S E R V I C E N O T E

**3245A Universal Source**

**Serial Numbers:** 2831A00000 / 2831A01289

**Incorrectly Labeled Line Voltage Switches May Cause Switch Setting Confusion**

**Figure 1. AC Line Voltage Switch Positions**

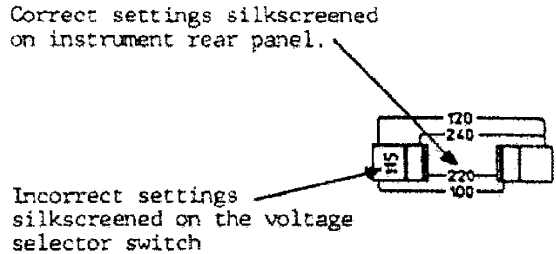
Some units may have incorrectly labeled line voltage selection switches installed. The correct settings appear silkscreened on the instrument rear panel. The incorrect settings are silkscreened on the voltage selection switches themselves.

No action is required. However, to avoid confusion, the incorrectly silkscreened line voltages may be easily scratched off using a flat-head screwdriver.
